ABBREVIATED PLAT AGENDA

STAFF REVIEW AND RECOMMENDATIONS PUBLIC HEARING JULY 31, 2024

LOON ISLAND

ABBREVIATED PLAT: RICHISON

LOON ISLAND

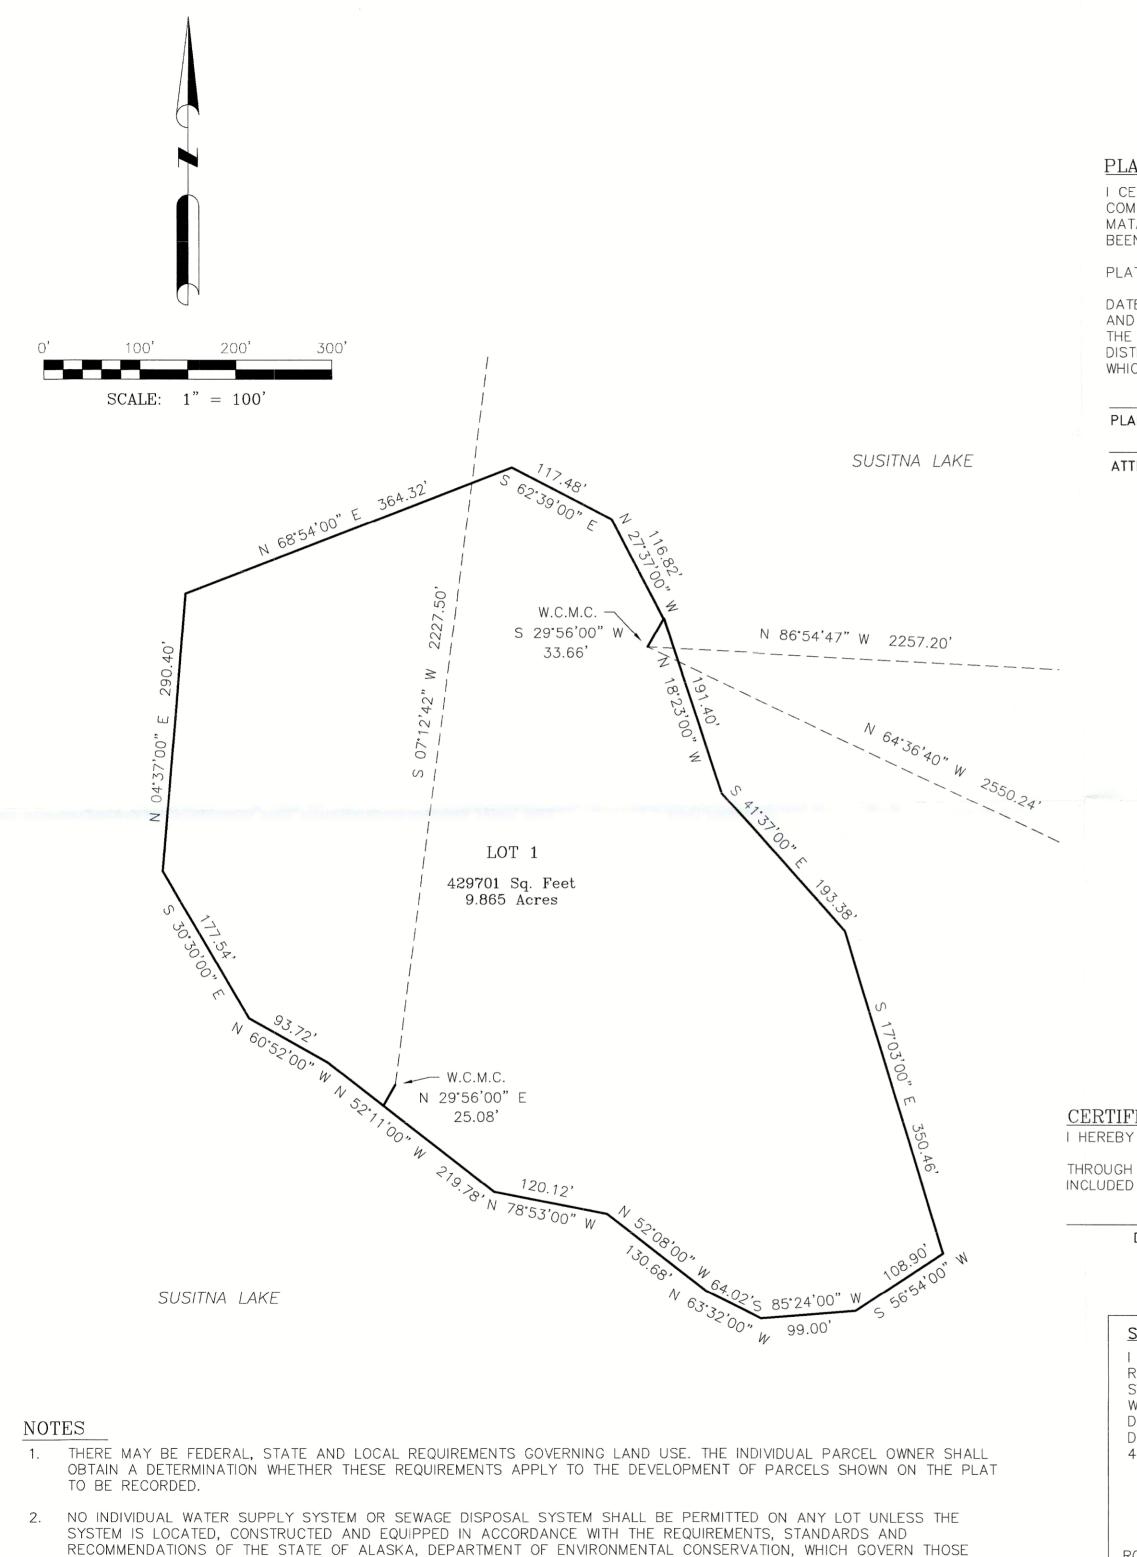
The Corps of Engineers (Corps) does not have any specific comments regarding Loon Island subdivision.

Department of the Army authorization is required if anyone proposes to place dredged and/or fill material into waters of the U.S., including wetlands and/or perform work in navigable waters of the U.S.

RICHISON SUBDIVISION TRACT A and TRACT B (MSB Case # 2024-083)

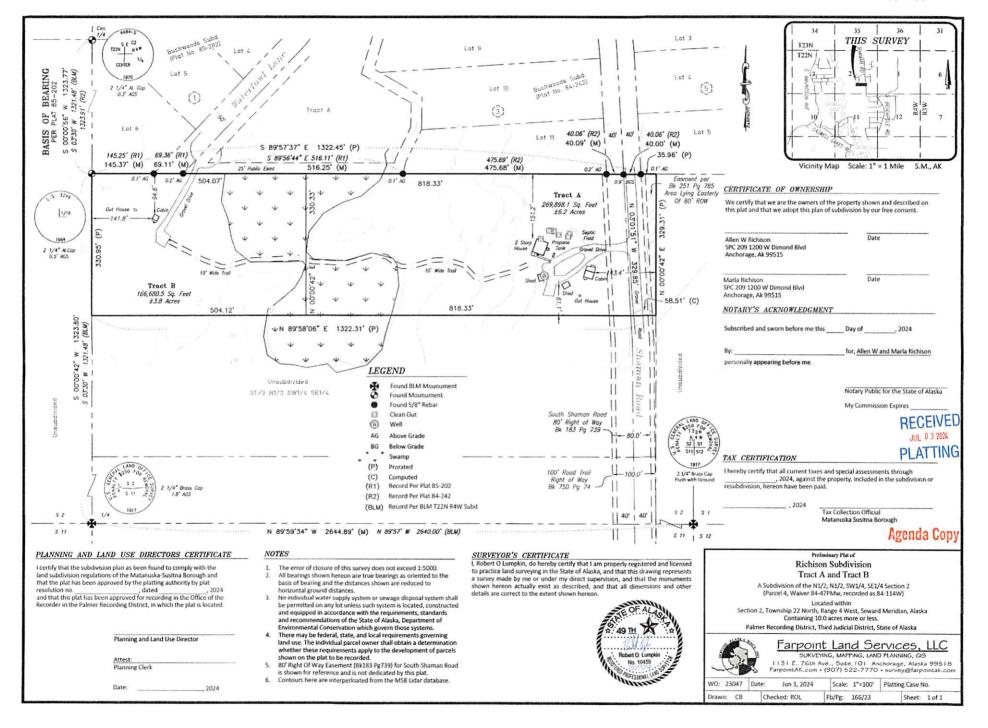
Department of Public Works (Exhibit C) notes that the petitioner will need to verify that Tract B has a minimum of 45' of frontage on the constructed temporary cul-de-sac of Waterfowl Lane (Recommendation #3).

Petitioner will need to prove that Tract B has a minimum 45' of frontage on the constructed temporary CDS of Waterfowl Ln.
